SUBJECT: ISSUANCE OF AMENDMENT NO.132 TO FACILITY OPERATING LICENSE
NO. NPF-29 - GRAND GULF NUCLEAR STATION, UNIT 1 (TAC NO. M97520)

SUBJECT: ISSUANCE OF AMENDMENT NO.132 TO FACILITY OPERATING LICENSE
NO. NPF-29 - GRAND GULF NUCLEAR STATION, UNIT 1 (TAC NO. M97520)

AMENDMENT TO FACILITY OPERATING LICENSE

SAFETY EVALUATION BY THE OFFICE OF NUCLEAR REACTOR REGULATION
RELATED TO AMENDMENT NO. 132 TO FACILITY OPERATING LICENSE NO. NPF-29

3.4.11

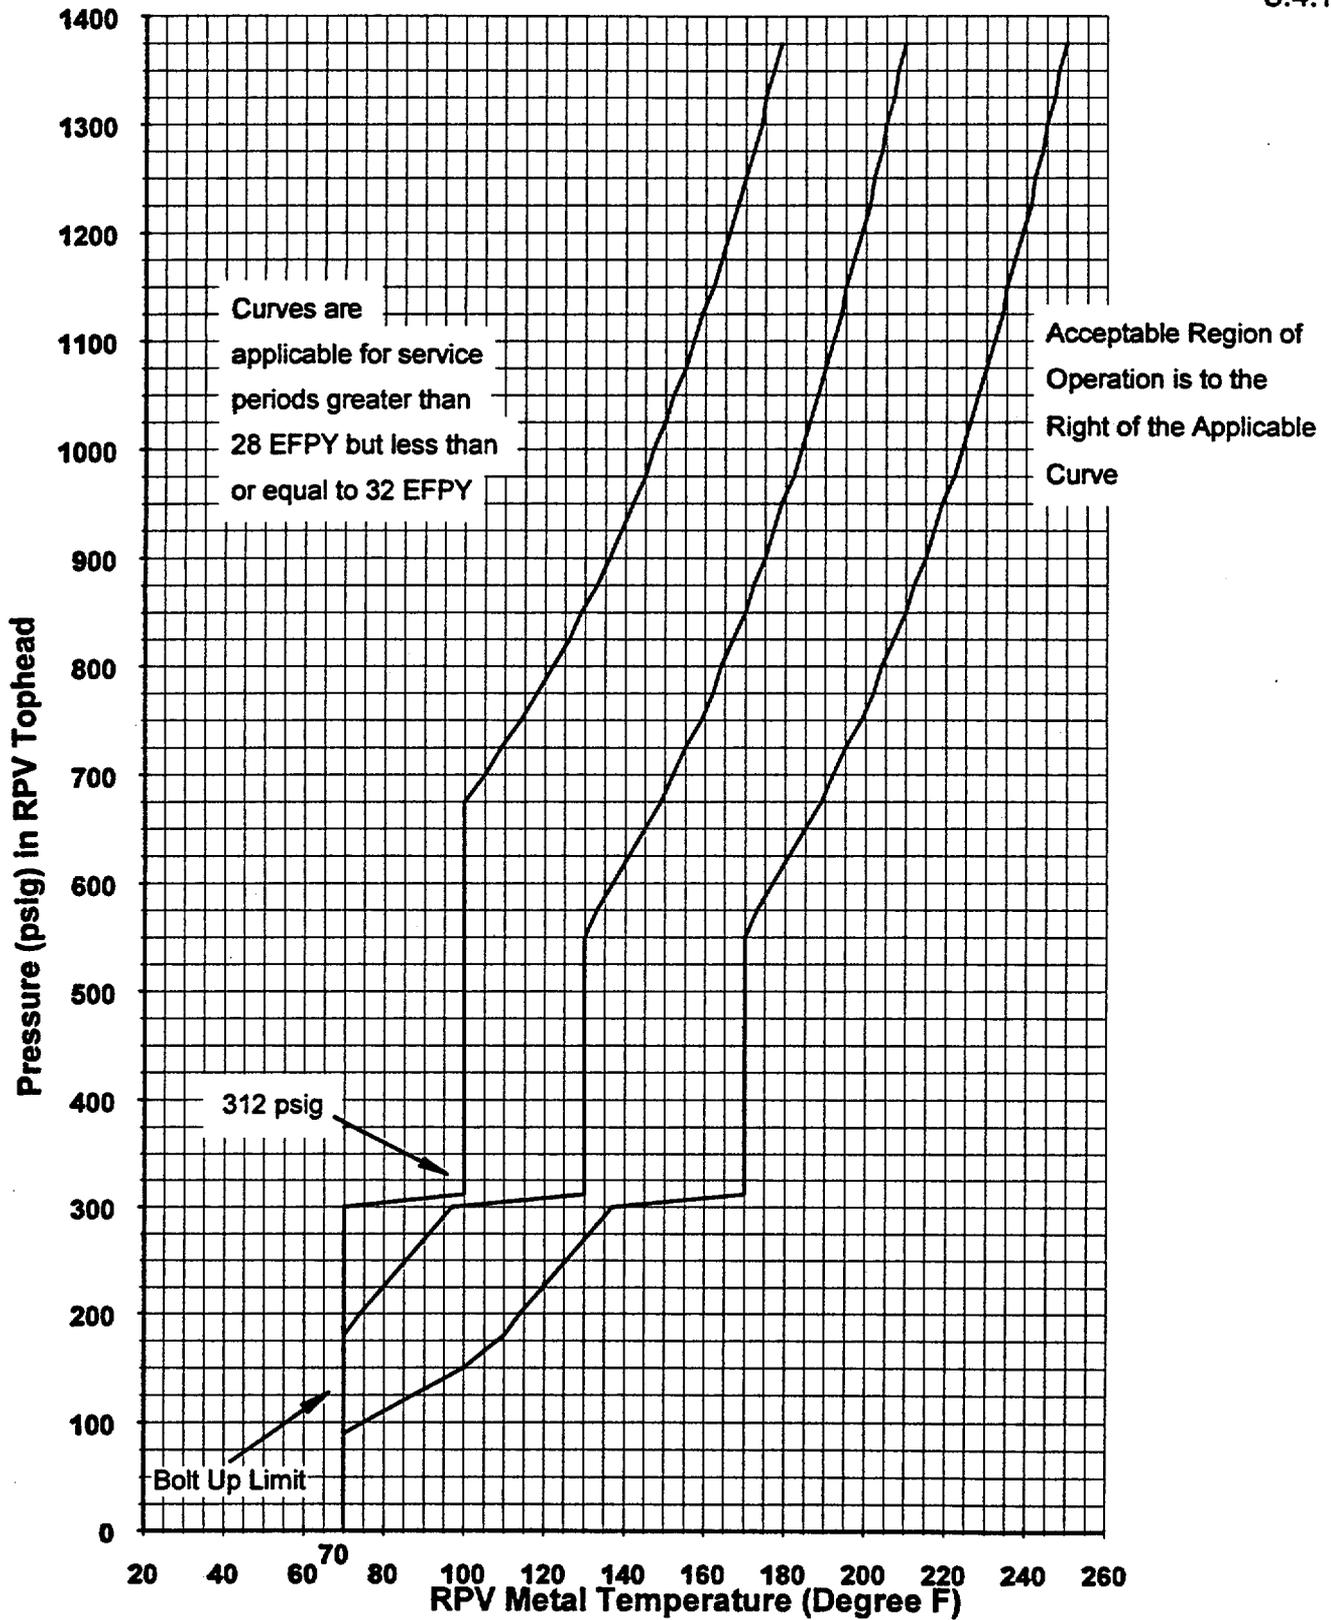
The amendment revised Figure 3.4.11-1 and Surveillance Requirements (SR) 3.4.11.1 and 3.4.11.2 of the TSs. The revisions to the pressure temperature (P-T) limits in Figure 3.4.11-1 extend the validity of the P-T limit curves from 10 effective full power years (EFPY) to 32 EFPY in increments. For each EFPY increment, there is a set of P-T limits in Figure 3.4.11-1 valid for the specified range of EFPY (i.e., Figure 3.4.11-1 is 5 figures). Further, paragraphs in the Bases and SRs in the TSs were revised to be consistent with the P-T limits. There are no commitments related to the amendment.

By application dated October 22, 1996, as supplemented by letter dated June 26, 1997 (References 1 and 2), Entergy Operations, Inc. (the licensee) proposed to amend Figure 3.4.11-1, "Minimum Reactor Vessel Metal Temperature vs. Reactor Vessel Pressure," and Surveillance Requirements (SR) 3.4.11.1 and 3.4.11.2 of the Technical Specifications (TSs) for Grand Gulf Nuclear Station, Unit 1 (GGNS). The proposed changes to the pressure temperature (P-T) limits in Figure 3.4.11-1 are to extend the validity of the P-T limit curves from 10 effective full power years (EFPY) to 32 EFPY in an initial increment of 6 EFPY, followed by constant increments of 4 EFPY (i.e., Figure 3.4.11-1 will be 5 figures). For each EFPY increment, there is a set of P-T limits in Figure 3.4.11-1 valid for the specified range of EFPY. Further, paragraphs under Bases and Surveillance Requirements in the TSs were revised by the licensee so that they will be consistent with the proposed P-T limits.

The staff evaluated the effect of neutron irradiation embrittlement on the beltline materials in the reactor vessels of Grand Gulf. The amount of irradiation embrittlement was calculated in accordance with RG 1.99, Rev. 2. The staff has determined that the material with the highest ART at 32 EFPY is the number (#) 2 shell axial welds, which was fabricated with weld wire heat number 627260, with 0.06% copper (Cu), 1.08% nickel (Ni), and an initial RT_{NDT} of -30°F . The ART calculated by the staff is 57.6°F at 1/4T for the limiting

material. The inner-diameter (ID) neutron fluence used in the calculation is $0.25E19$ n/cm² for 32 EFPY. This ART is the same as that calculated by the licensee. Substituting the ART of 57.6°F into equations in SRP 5.3.2, the staff verified that the proposed P-T limits (for 32 EFPY) for heatup, cooldown, and hydrotest meet the beltline material requirements in Appendix G of 10 CFR Part 50.

The licensee's fluence of $0.25E19$ n/cm² for 32 EFPY is not consistent with the corresponding value of $0.311E19$ n/cm² in NRC's reactor vessel integrity database (RVID). The licensee clarified in Reference 2 that the higher fluence value is the upper-bound fluence and does not need to be used in the P-T limits calculation. The licensee's P-T limits consist of 5 sets of curves, with EFPY values varying from 16 to 32 in a constant increment of 4 EFPY. The staff found that a linear relationship was assumed by the licensee to obtain ID fluence values for EFPYs less than 32. For additional assurance, the staff also verified the P-T limits for 16 EFPY in a manner similar to what is described above.

The major portion of the proposed P-T limit curves is defined by the beltline limiting material. However, certain part of the P-T limit curves is either bottom head or feedwater nozzle controlled. The methodology for these non-beltline regions was documented in Reference 2, and was found to be consistent with that used to support the P-T limits of Clinton (1996), Oyster Creek (1997), and Hatch (1997) nuclear power plants. This methodology was based on a finite element analysis of a generic BWR (Boiling Water Reactor) Type 6 vessel for an applied pressure of 1593 psig for the bottom head, and for the most severe transient with cold 40°F feedwater injection at normal operating condition (551.4°F and 1050 psig) for the feedwater nozzle. GGNS is a BWR Type 6 plant. The results from the generic analysis were then adjusted according to the plant-specific initial RT_{NDT} value of the bottom head or feedwater nozzle material. The staff determines that this methodology is consistent with WRC Bulletin 175 and the Appendix G of the ASME Code, and is acceptable to the staff.

Appendix G of 10 CFR Part 50 also imposes P-T limits based on the reference temperature for the reactor vessel closure flange materials. Section IV.A.2 of Appendix G states that when the pressure exceeds 20% of the preservice system hydrostatic test pressure, the temperature of the closure flange regions highly stressed by the bolt preload must exceed the reference temperature of the material in those regions by at least 120°F for normal operation and by 90°F for hydrostatic pressure tests and leak tests. Paragraph IV.A.3 of Appendix G states, "an exception may be made for boiling water reactor vessels when water level is within the normal range for power operation and the pressure is less than 20 percent of the preservice system hydrostatic test pressure." The staff examined the current and the proposed P-T limits, and found that this portion of the curves (straight line segments) remains the same. Therefore, the staff determined that the proposed P-T limits satisfy the requirements in Sections IV.A.2 and IV.A.3 of Appendix G.

The staff has reviewed the information provided by the licensee in its letters of October 22, 1996, and June 26, 1997 (References 1 and 2). The staff has determined that the licensee used methodologies consistent with Appendix G to 10 CFR Part 50, Appendix G to Section XI of the ASME Code, and SRP Section 5.3.2. Based on this determination, the licensee's proposed sets of P-T limits for heatup, cooldown, leak test, and criticality, which are valid for their specified EFPY ranges, may be incorporated into the TSs for GGNS. Further, the proposed bases and surveillance requirements are consistent with the proposed P-T limits. Therefore, the proposed changes to the TSs are acceptable.
